**Subject: MHI's Response to US-APWR DCD RAI No. 306-2333 Revision 1**

**MHI's Response to US-APWR DCD RAI No. 306-2333 Revision 1**

**US-APWR Design Certification  
Mitsubishi Heavy Industries  
Docket No. 52-021**

**RAI NO.:** NO. 306-2333 REVISION 1  
**SRP SECTION:** 15.03.01 – 15.03.02 – LOSS OF FORCED REACTOR COOLANT FLOW INCLUDING TRIP OF PUMP MOTOR AND FLOW CONTROLLER MALFUNCTIONS  
**APPLICATION SECTION:** 15.3.1 – 15.3.2  
**DATE OF RAI ISSUE:** 4/02/2009

**Figure 15.3.1-1.1 DNBR versus Time with and without LOOP  
Partial Loss of Forced Reactor Coolant Flow**

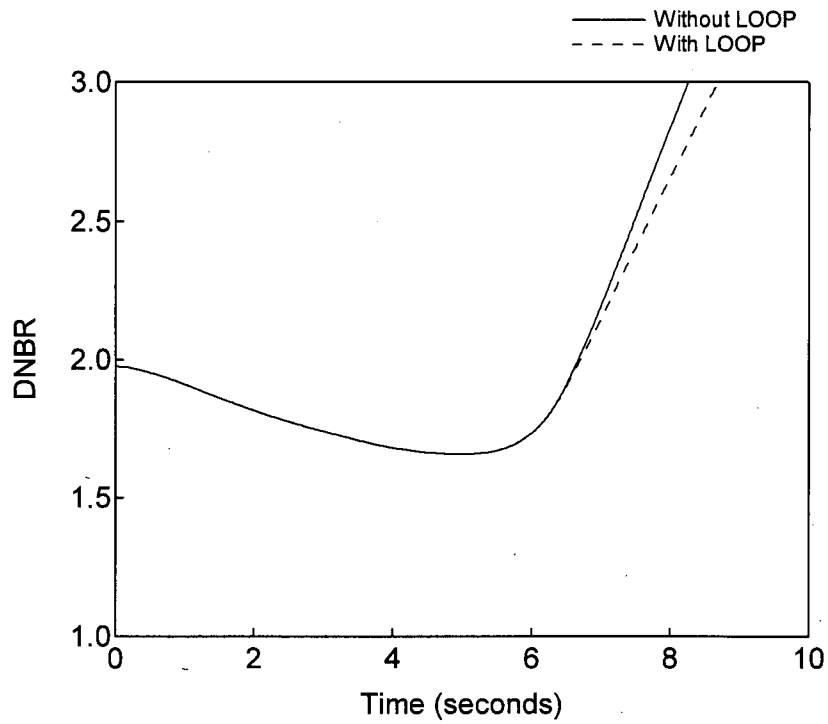
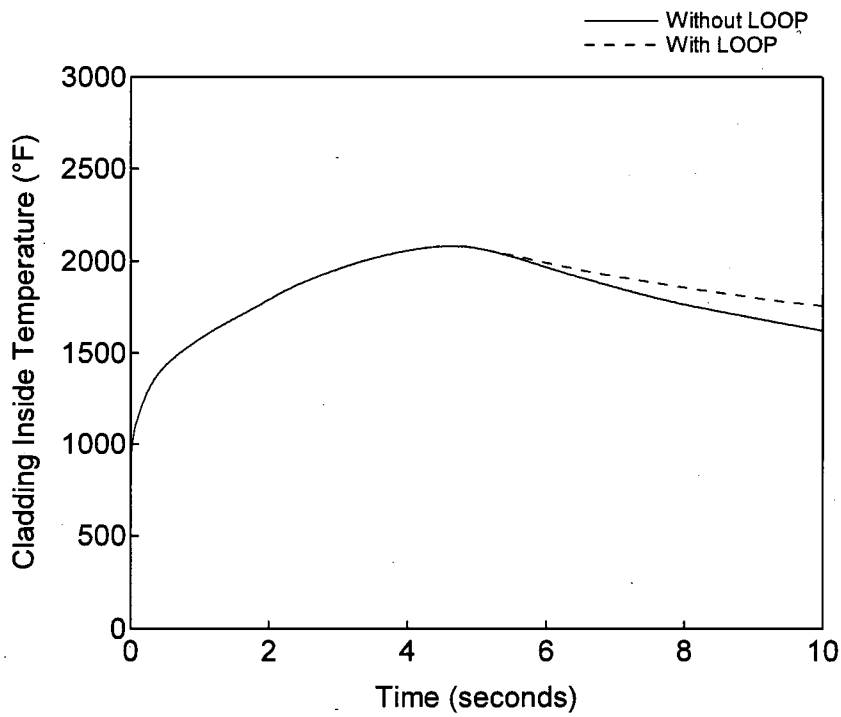
SRP Sections 15.3.1-2 and 15.3.3-4 state, "For new applications, LOOP should not be considered a single failure; [all AOOs] should be analyzed with and without LOOP in combination with a single active failure." In compliance with this requirement, provide the results of calculations that include the occurrence of a LOOP unless otherwise exempted by the NRC staff. If exempted by the NRC, provide documentation of the exemption.

For the event in DCD Subsection 15.3.1.1 (partial loss of forced reactor coolant flow), the basis for the limiting DNBR occurring prior to the RCP coastdown (i.e. the LOOP analysis is not necessary) will be provided in the response to RAI 297-2287 Question 15.0.0-3. However, the transient curve for DNBR for the 15.3.1.1 analysis considering a LOOP occurs 3 seconds after the turbine trip (turbine trip is assumed to occur at the same time as reactor trip) which causes the other two RCPs to coast down is shown below in Figure 15.3.1-1.1. For comparison, the same event without LOOP is shown on the same curve. For the event in DCD Subsection 15.3.1.2 (complete loss of forced reactor coolant flow), all of the RCPs trip as the initiating event of this transient, so it is not necessary to consider a LOOP. For the RCP rotor seizure event presented in DCD Subsection 15.3.3, the basis for not considering LOOP will also be covered by the response for RAI 297-2287 Question 15.0.0-3. However, the transient curve for cladding inside temperature for the 15.3.3 analysis considering a LOOP occurs 3 seconds after turbine trip (turbine trip is assumed to occur at the same time as reactor trip) which causes the other three RCPs to coast down is shown below in Figure 15.3.1-1.2. Again, the event without LOOP is shown on the same figure for comparison.

**Figure 15.3.1-4.1 Steam Generator Pressure versus Time  
Partial Loss of Forced Reactor Coolant Flow**

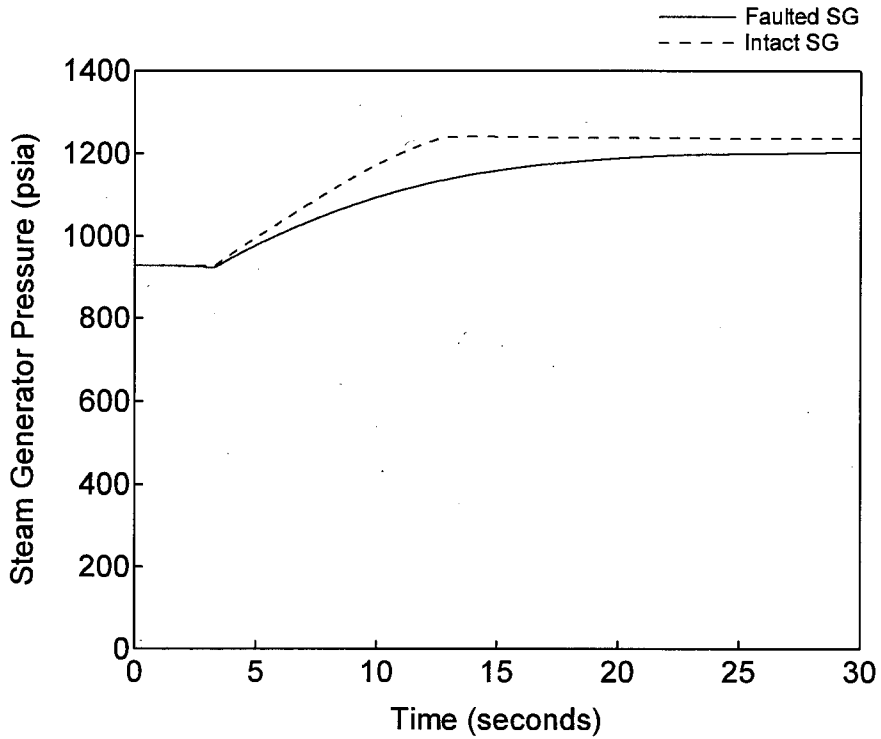
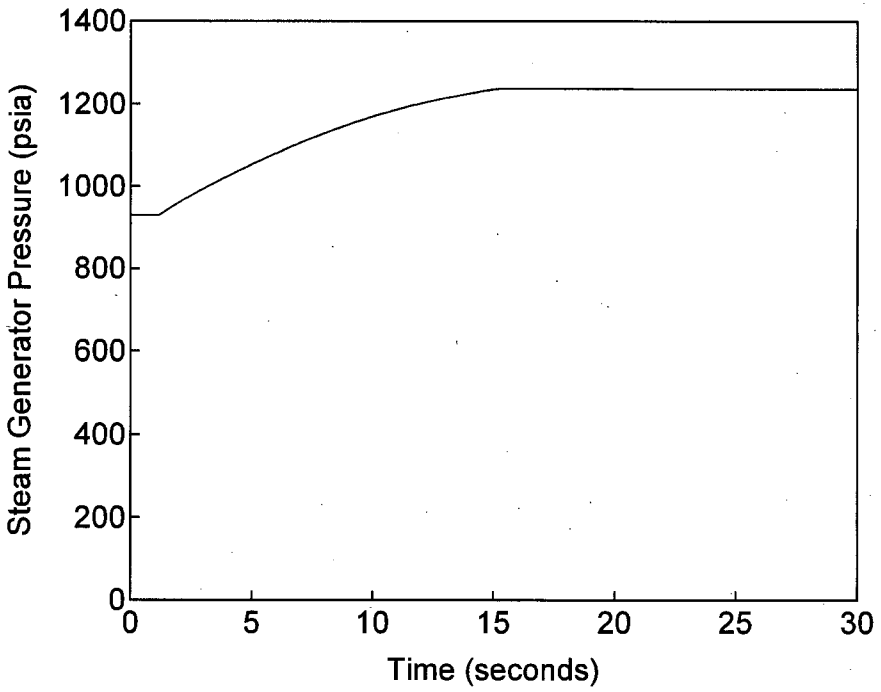
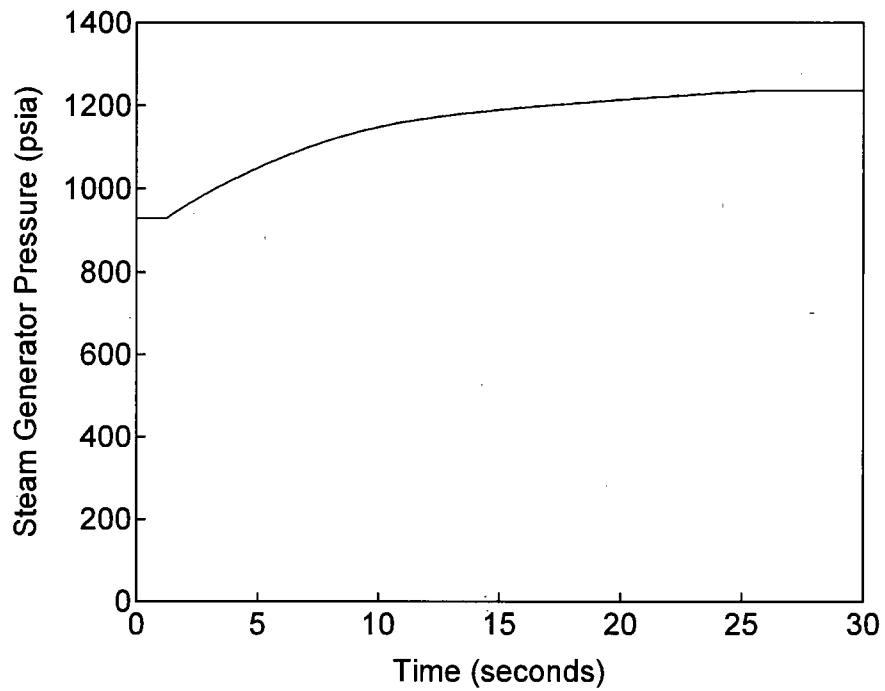
Provide the transient curve for Steam Generator Pressure verses time in the analysis for Loss of Flow event in Section 15.3.1.

The transient curves for the steam generator pressure versus time for the analyses in DCD Subsection 15.3.1, for partial loss of flow, complete loss of flow, and frequency decay resulting in a complete loss of flow, are shown below in Figures 15.3.1-4.1 through 15.3.1-4.3, respectively. The SG safety valve is modeled assuming 103% of the SG design pressure (1236 psia) . These steam generator pressure figures confirm the statement in Subsections 15.3.1.1.3.3 and 15.3.1.2.3.3 that the steam line pressure for these events are bounded by that of the RCP rotor seizure event which is less than 110% of the design pressure.

**Figure 15.3.1-7.1 Fuel Centerline Temperature versus Time  
Partial Loss of Forced Reactor Coolant Flow**

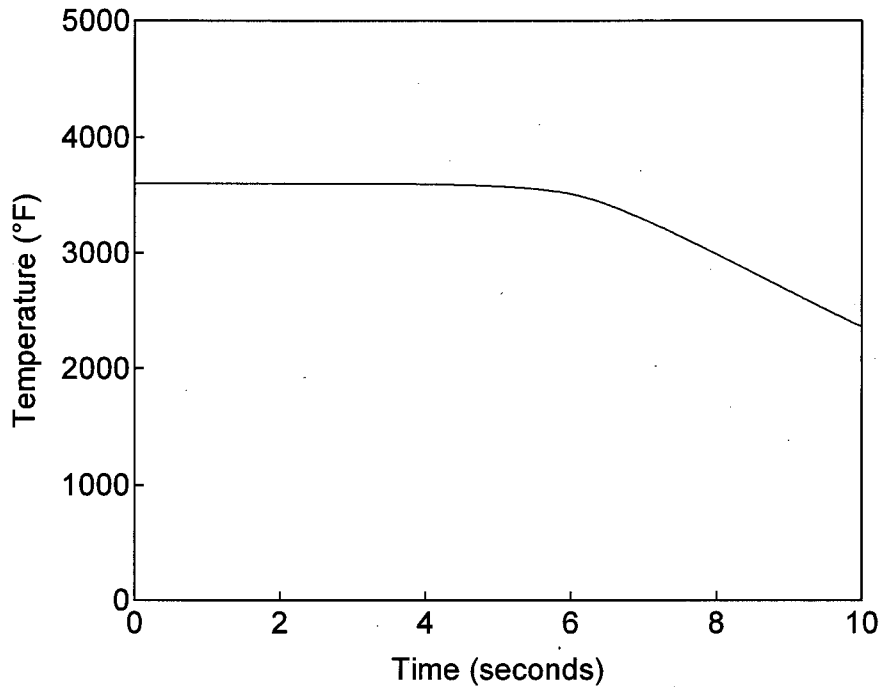
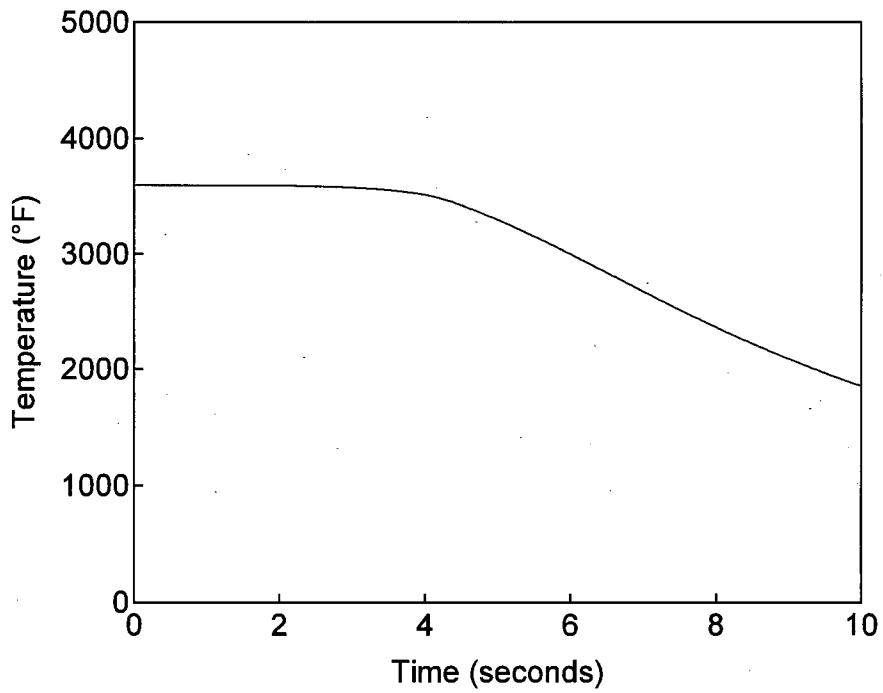
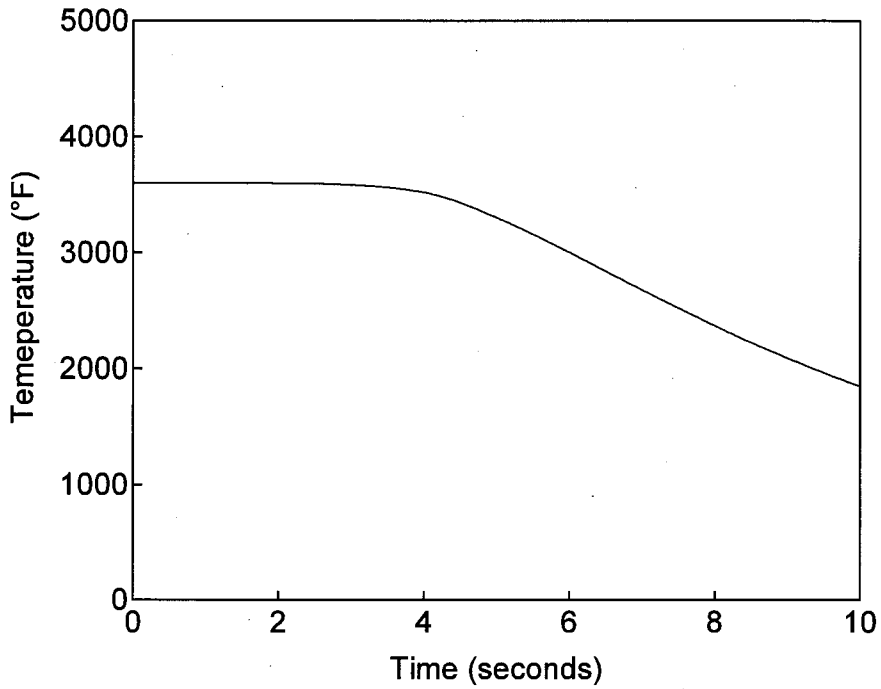
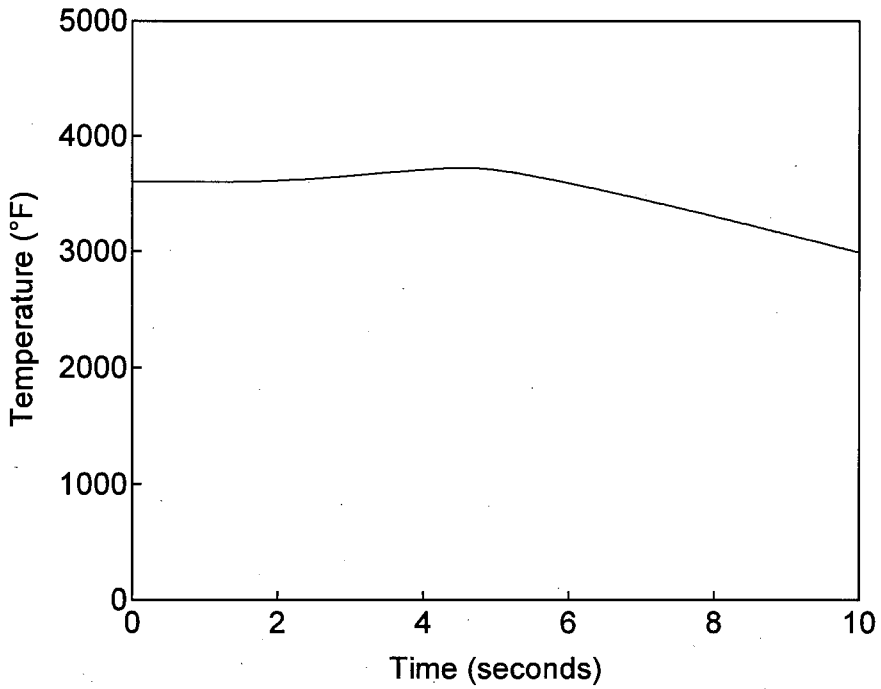
Plot the peak fuel centerline temperature as a function of time for the reactor transients in Sections 15.3.1 through 15.3.4 and explain the associated safety limit.

The plots of the peak fuel centerline temperature as a function of time for the reactor transients in DCD Subsection 15.3.1, partial loss of flow, complete loss of flow, and frequency decay resulting in a complete loss of flow, are shown below in Figures 15.3.1-7.1 through 15.3.1-7.3, respectively. As described in DCD Subsection 15.3.2, the flow controller malfunction event is not applicable to the US-APWR and is not analyzed. The plot of the peak fuel centerline temperature as a function of time for the reactor transient in DCD Subsection 15.3.3, the RCP rotor seizure, is shown below in Figure 15.3.1-7.4. This case conservatively assumes the film boiling coefficient from the beginning of the accident because DNB occurs in the RCP rotor seizure event as described in DCD Subsection 15.3.3.2. As described in DCD Subsection 15.3.4, the RCP shaft break event is bounded by the conservative analysis in DCD Subsection 15.3.3.

The US-APWR applies the following criterion as the safety limit in the fuel centerline temperature analyses for both AOOs and PAs:

- The maximum fuel centerline temperature should be less than the fuel melting point so that the fuel cladding will not be mechanically damaged.

The fuel pellet melting temperature is described in DCD Subsection 4.2.1.2.1 and Table 4.1-1 (sheet 2 of 3). The melting temperature is 5072°F (2800°C) for un-irradiated uranium dioxide (UO<sub>2</sub>) fuel, and decreases with burnup by 58°F (32°C) per 10 GWD/MTU. Maximum fuel centerline temperature during AOOs is 4620°F which is decreased by a fuel temperature uncertainty of 452°F (about 250°C).

In the Chapter 15 analyses concerning fuel centerline temperature, 4620°F is used as the safety limit for AOOs. In case of the PAs, a fuel temperature uncertainty is considered in advance by including it in the initial fuel temperature. The safety limit is based on the melting temperature
